Access Compliance Report Public Rights-of-Way (Curb Ramps)

Main Street: MIRA_LOMA_PL Cross Street: IRVINE_AVE Location: N

ADA ID: RPRK211018115929 Ramp Type: Type 4 - Parallel Initial Pass/Fail: Pass Overall Compliance: No Severity Score: 0

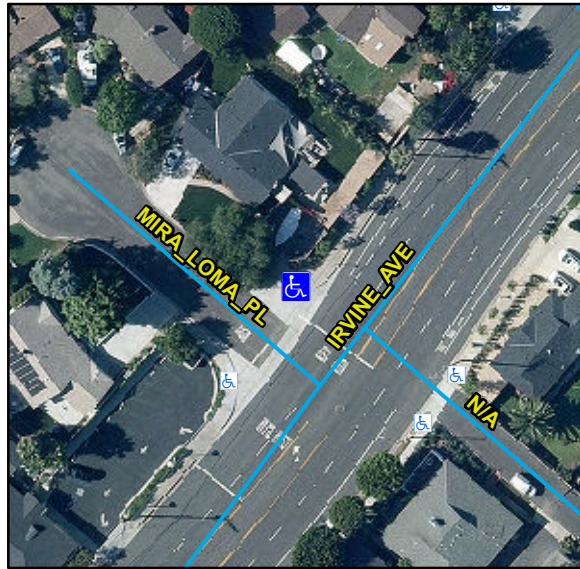
Remove & Replace Curb Slope.

N/A	Ramp Inside Crosswalk 1	N/A	N/A	Ramp Inside Crosswalk 2	N/A
	Crossing 1 Slope (%)	3.4		Crossing 2 Slope (%)	5.8
	Crossing 1 Cross Slope (%)	2.9		Crossing 2 Cross Slope (%)	1.9
Yes	Gutter Ponding	No	No	Curb Slope	10.1
Yes	Gutter Lip Height (in)	0		Road Run Slope (%)	1.5
Yes	Gutter Run Slope (%)	2.1		Road Cross Slope (%)	0.2
Yes	Gutter Cross Slope (%)	1	Yes	Perpendicular Joint Present	Yes
Yes	Overall Surface Condition	Acceptable			
	Cross Gutter Present?	Yes		Spandrel Present?	Yes
	Replace Cross Gutter?	No		Replace Spandrel?	No

R304.2.2, STD 1115
